Appl. No. 10/634,499 Amendment dated August 1, 2006 Reply to Office Action of March 2, 2006

## Amendments to the Drawings:

FIGS. 4-5 of the present application (annotated - not to scale)

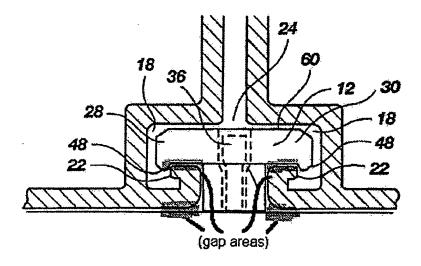
As can be seen from the above figures, the lower lip thickness provided by West is substantially less than the average height of its protrusion. As is evidenced by the gap areas highlighted above, West's lower lip thickness is substantially less than the protrusion height at all areas except those between the nub (48) and the lip edge (22). Further, the size of the nub (48) is minimal compared to the areas of the protrusion lacking the nub (48), thereby rendering the thickness of West's lower lip substantially *less* than the average vertical distance from the fastener base to the fastener protrusion. In contrast, the present application discloses and now claims a lower lip

thickness being at least 1% greater than the average vertical distance from the fastener base to the

fastener protrusion. Such a configuration facilitates the securement of boards to joists and the
